Service Letter #: SL21 66-47200

Part/Assembly #: 66-47200

Float Model Affected: Aerocet Model 6650 floats

Affected: Hydraulic Pump Motor

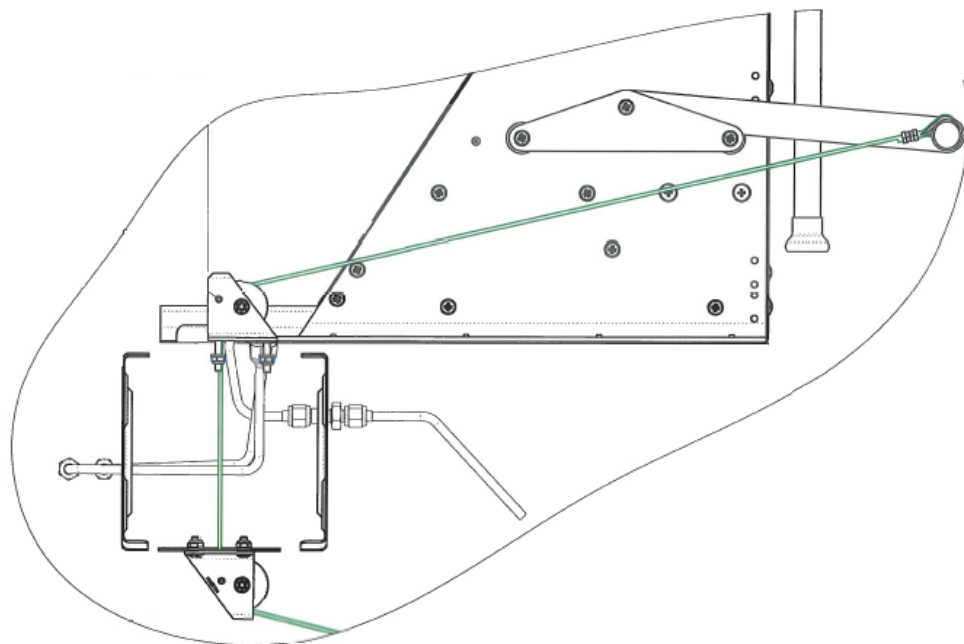
Reason for Change: Premature gear wear

Corrective Action: Remove and replace hydraulic pump motor.
